HISTORIC AND DESIGN REVIEW COMMISSION

HDRC CASE NO: 2021-479
ADDRESS: 411 N MONUMENTAL
LEGAL DESCRIPTION: NCB 1373 BLK 1 LOT 35
ZONING: RM-4, H
CITY COUNCIL DIST.: 2
DISTRICT: Dignowity Hill Historic District
APPLICANT: Pegy Brimhall/Figrd, LLC
OWNER: Monica Naves/Vergel Constructions, LLC
TYPE OF WORK: Construction of a 1-story, residential structure with a detached rear accessory structure
APPLICATION RECEIVED: September 21, 2021
60-DAY REVIEW: Not applicable due to City Council Emergency Orders
CASE MANAGER: Edward Hall

The applicant is requesting a Certificate of Appropriateness for approval construct a 1-story, single family residential structure on the vacant lot at 411 N Monumental, located within the Dignowity Hill Historic District. The applicant has also proposed to construct a rear accessory structure.

Sheet Contents:
Covered Parking
Plans and
Elevations

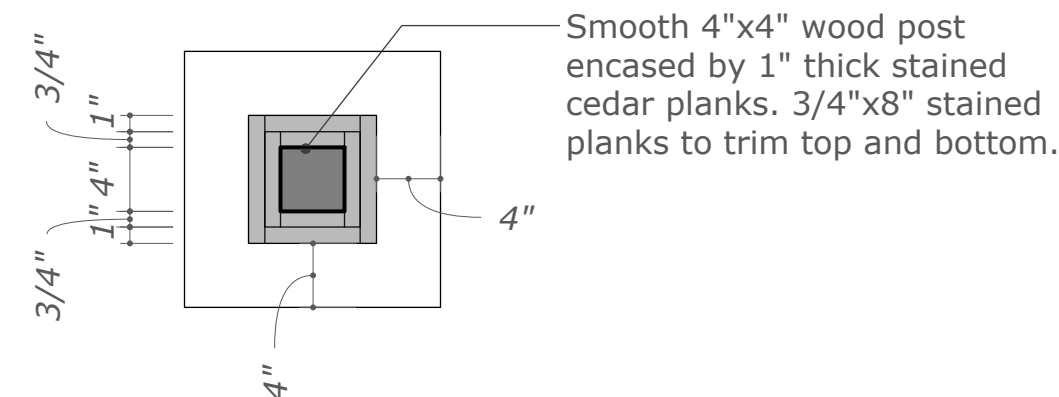
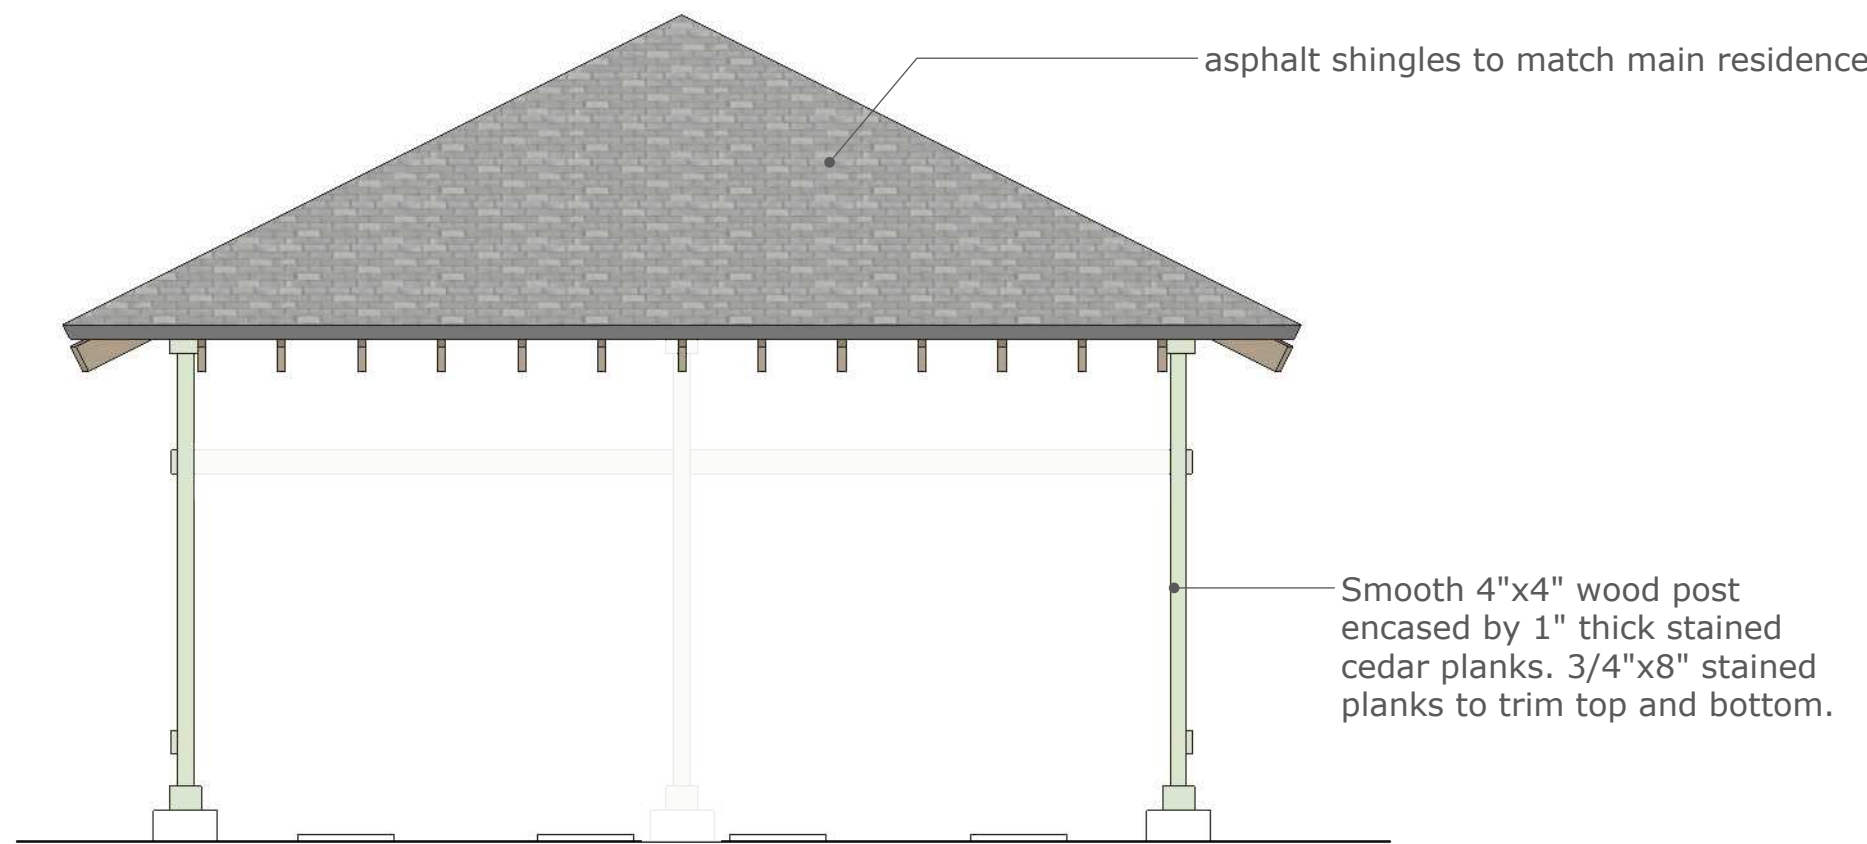
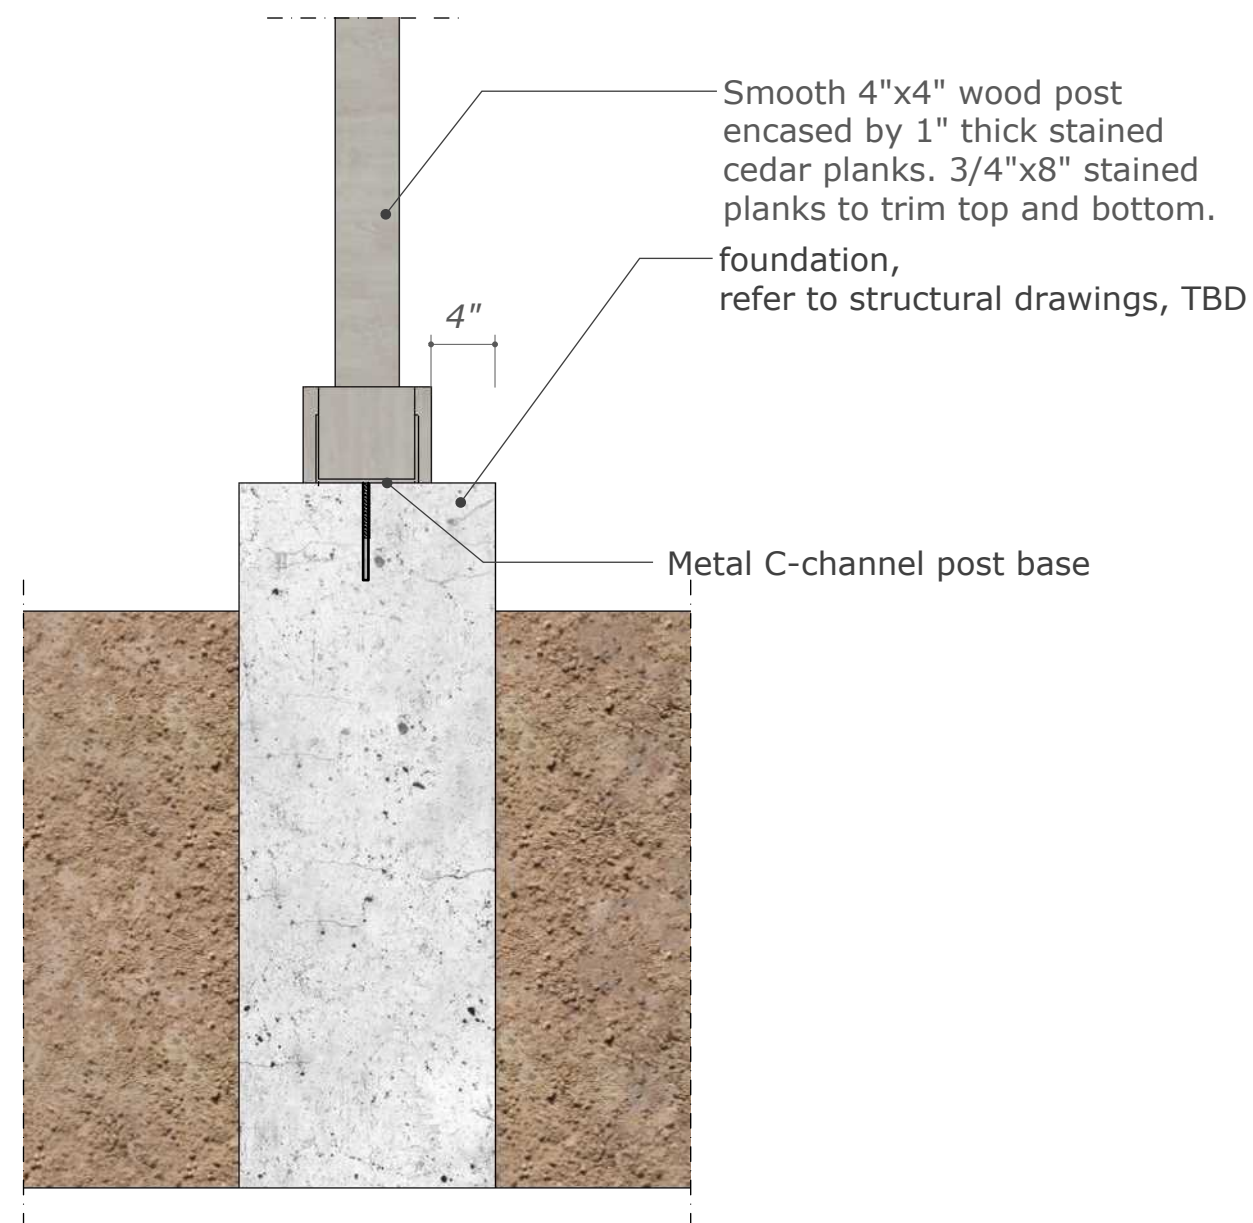
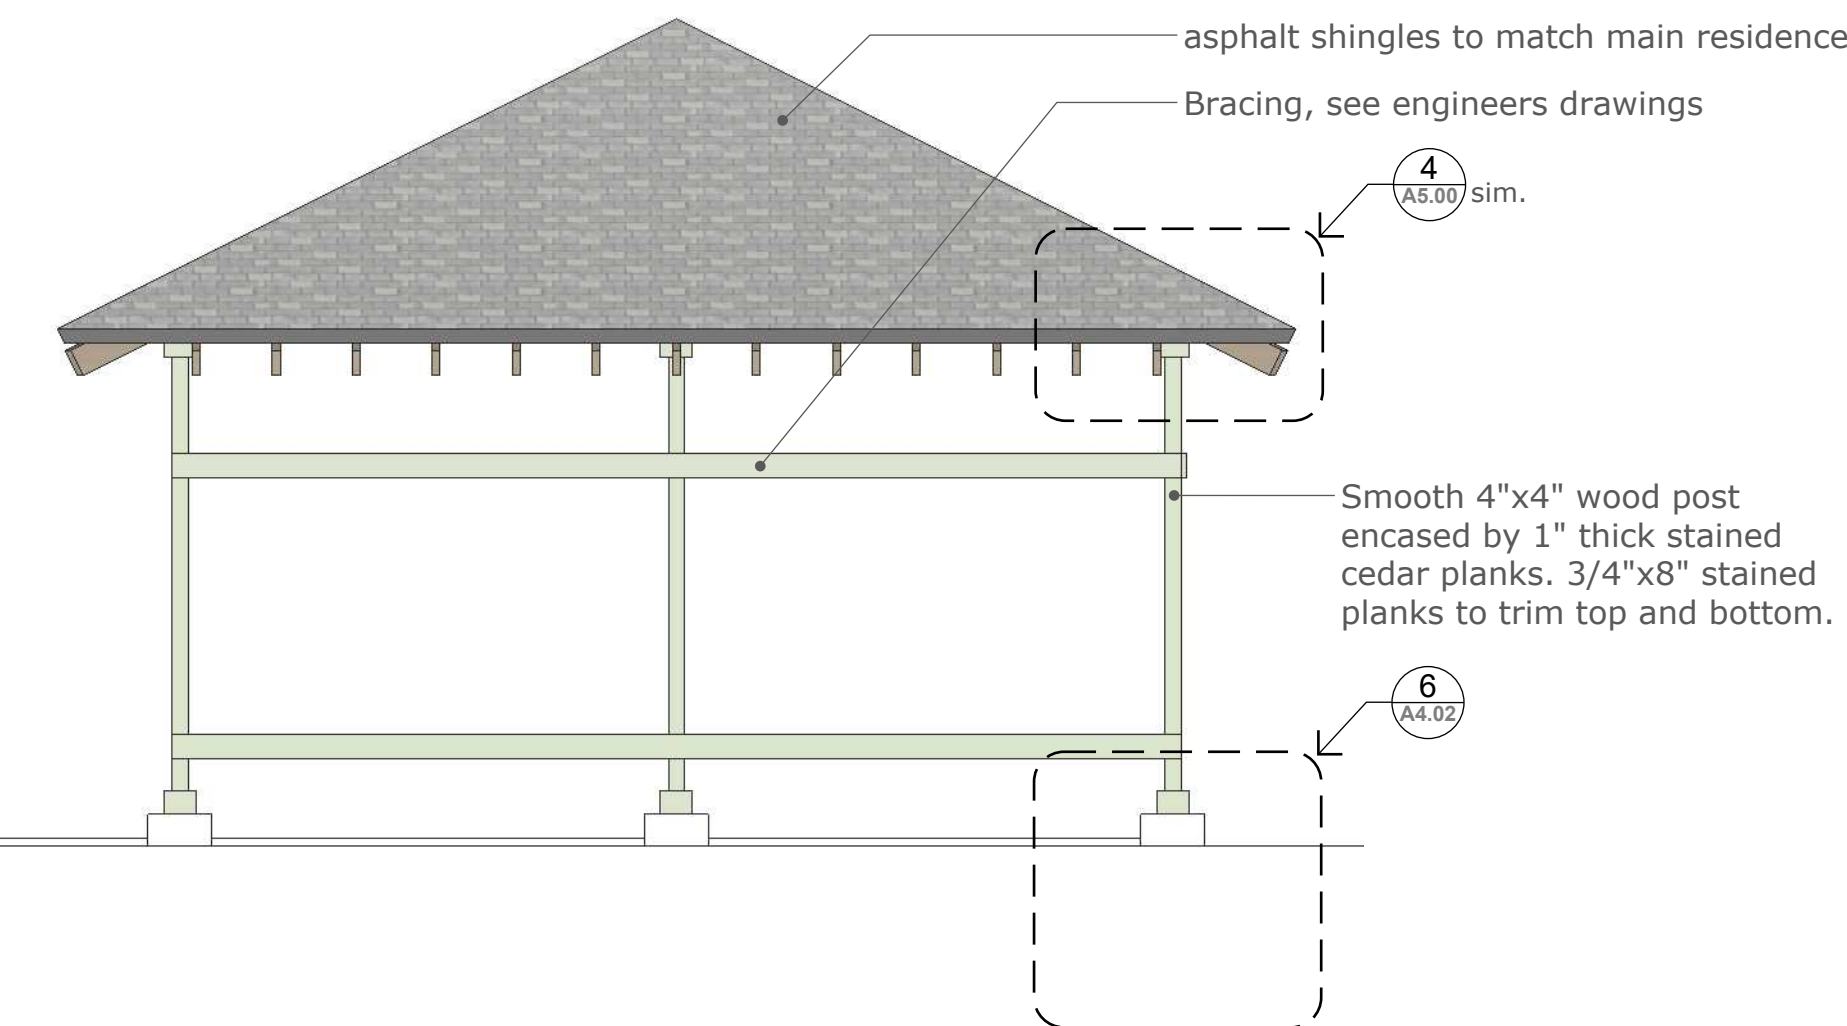
- p. REAR ACCESSORY STRUCTURE – The applicant has proposed to construct a carport at the rear of the lot to feature access to Goodloe Alley. Generally, staff finds the location, massing and footprint of the proposed accessory structure to be consistent with the Guidelines for New Construction.
